# UNITED STATES PATENT AND TRADEMARK OFFICE

10/540,089

**Office Action Summary****Application No.**

### DETAILED ACTION

Figure 1

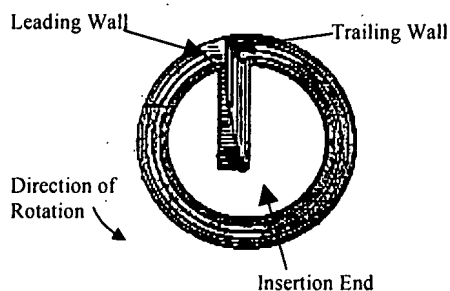
Regarding claim 11, Olson discloses a device comprising a generally cylindrical anchoring portion and a number of slots extending from the insertion end (see Figure 1 below). The anchoring portion includes an insertion end and includes an external screw thread. The slots are defined by a leading slot wall and a trailing slot wall related to the direction of rotation defined by the external thread, wherein at least the radial outermost part of the trailing slot wall defines an angle alpha with the radial direction and slopes obliquely forward from within and outwardly in the direction of rotation. Regarding claim 12, Olson discloses a device wherein the entire trailing slot wall defines the angle alpha with the radial direction. Regarding claim 13, Olson discloses a device wherein the leading slot wall also slopes obliquely forward from within and outward in the direction of rotation. Regarding claim 14, Olson discloses a device wherein the leading and trailing slot walls are parallel with one another. Olson fails to disclose a device further comprising a cavity that opens out at the insertion end in communication with the slots, wherein the cavity includes a circular cross-section and widens conically in a direction towards the insertion end. Guedj teaches a device comprising an anchor portion

including a cavity that opens out at an insertion end in communication with slots, wherein the cavity includes a circular cross-section and widens conically in a direction towards the insertion end in order to guide bone shavings cut by the slots in the direction of the cavity (column 3 lines 11-18). It would have been obvious to one having ordinary skill in the art at the time the invention was made to manufacture the device of Olson further comprising a cavity that opens out at the insertion end in communication with the slots, wherein the cavity includes a circular cross-section and widens conically in a direction towards the insertion end in view of Guedj in order to guide the bone shavings cut by the slot in the direction of the cavity.
